Model	Finisher for F410	Volt/Hz	Date of Modification	Serial Number
Modified Article	Parts Catalog			
Reason for Modification	Parts catalog correction

Model	Finisher for F410	Volt/Hz	Date of Modification	Serial Number
Modified Article	Exit Transport Roller etc.			
Reason for Modification	To improve the paper stuck in jogger unit

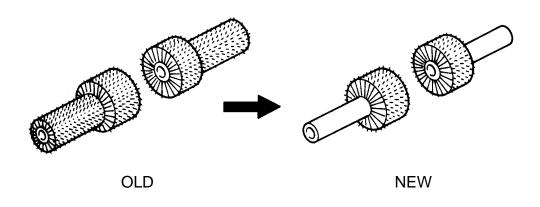
0115/11	Old P/N New P/N Description Q'ty U			Inter-	Parts Catalog	
Old P/N		Q'ty Used	change- ability	Index No.	Page	
A3792610	A3532116	Paddle Roller	$4 \rightarrow 4$		14	13
A3792610 —		Exit Transport Roller	2 → 0		15	13
	→ A3792617	Paddle	0 → 2		15	13

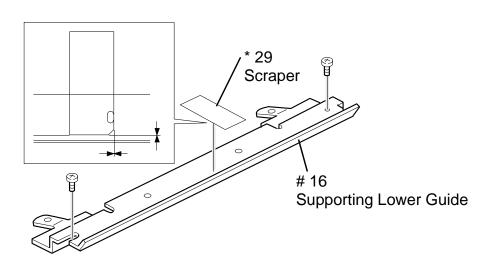
Model	Finisher for F410 / 420	Volt/Hz	Date of Modification	Serial Number
Modified Article	Supporting Lower Plate / Scraper / Lock Pin Spring			
Reason for Modification	To prevent the positioning roller from being marked

OLL DAL	N. DA			Inter-	Parts Catalog	
Old P/N	New P/N	Description	Q'ty Used	change- ability	Index No.	Page
A4582479		Lock Pin Spring	$ 6 \rightarrow 0 \\ 4 \rightarrow 0 \\ 2 \rightarrow 0 $	X/	10 5 19	5 7 13
	— AA063529	Pressure Spring - 14.5mm	$\begin{array}{c} 0 \rightarrow 6 \\ 0 \rightarrow 4 \\ 0 \rightarrow 2 \end{array}$	/O	10 5 19	5 7 13
A3792512	A3792519	Supporting Lower Guide	1 → 1	X/O	18	13
	A3792515	Scraper	0 → 1	7/0	* 29	13

If some kinds of paper which contain a lot of Calcium Carbonate are used, the toner in halftone image areas cannot be fused onto the paper completely. The positioning roller picks up this unfused toner and becomes contaminated, and this may cause a positioning roller mark to appear on the copy paper. To prevent this, a scraper has been stuck on the supporting lower guide to keep the roller surface clean. At every PM visit, please remove the scraped toner which is stuck on the lower guide plate.

2. Lock Pin Spring

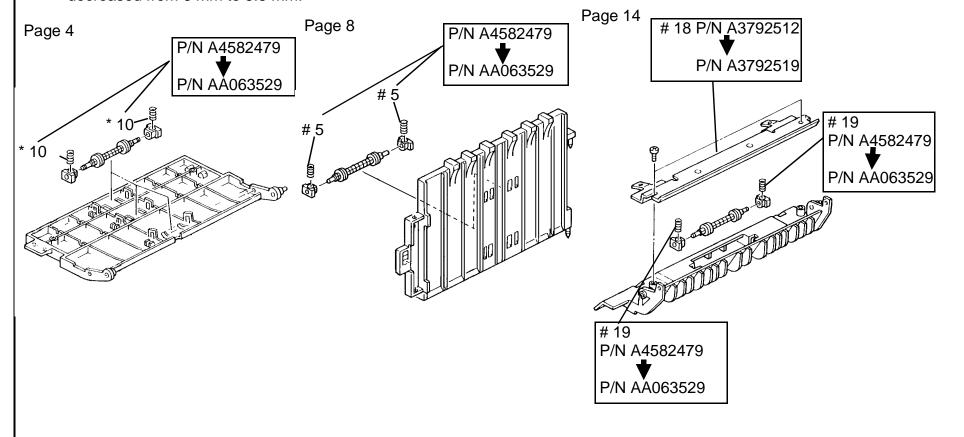
To facilitate servicing, the outer diameter of the spring has been changed from 7 mm to 6.5 mm. As a result of this diameter change, the spring positioning pins on the supporting lower guide have been decreased from 6 mm to 5.5 mm.

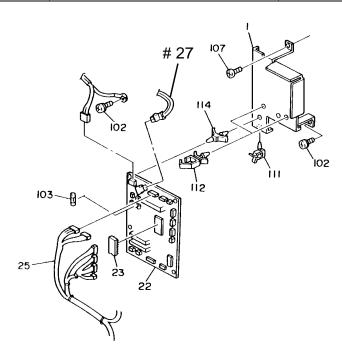
The following part number is missing in the Parts Catalog, Please correct your Parts Catalog.

New P/N	Description	Q'ty Used	Parts Catalog		
New P/N	Description	Q ty Osed	Index No.	Page	
AW030033	Fiber Cable	0 → 1	* 27	21

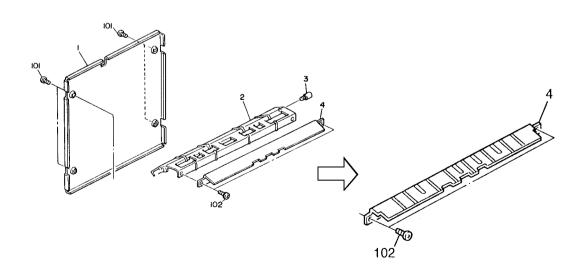
The following part has been changed to standardize with other models.

Old P/N New P/N			Inter-	Parts Catalog		
	New P/N	Description	Q'ty Used	change- ability	Index No.	Page
A3772126	A6062126	Relay Guide	1 → 1	O/O	4	9

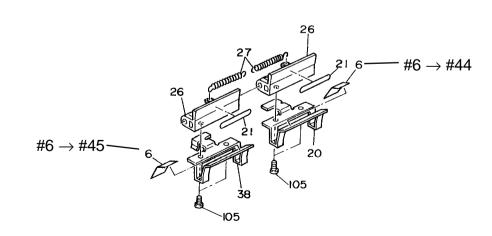
Due to parts standardization, the rear stapler positioning fence has been changed.

OLL DAL	N D/N	5	011 11	ty Used change- ability	Parts Catalog	
Old P/N	New P/N	Description	Q'ty Used		Index No.	Page
A379 4259		Positioning Fence Mylar	2 → 0	O/	6	9
-	A612 4258 Positioning Fence Mylar Rear		0 → 1	/O	44	9
	A612 4259	Positioning Fence Mylar Front	0 → 1	/O	45	9
